FCC CLASS II PERMISSIVE CHANGE REQUEST LETTER

RE: FCC Permissive II Change Request for Company: Lightcomm Technology Co.,Ltd. FCC ID: Y34-UITBSM

We are submitting an application for a class II permissive change to the FCC approval of the Company name: **Outform Ltd**, product description: MID (FCC: **Y34-UITBSM**, Original Grant Date: Nov. 04, 2015). The transmitter module itself has not changed. The LED drives board has changed version number from V1.1 to V1.3,here are the changes:

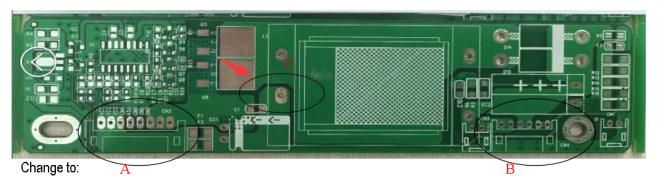
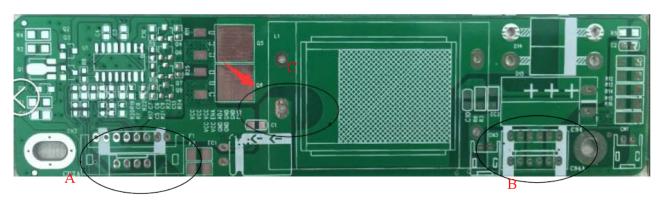
A:add CN2A/PH2.0 * 4 pin DC input socket

B: add CN4A/PH2.0 * 6 pin backlit output socket

C: Increases the distance L1 inductance between PIN4 feet square copper foil and copper foil, in order to prevent the L1 - PIN4 short-circuit
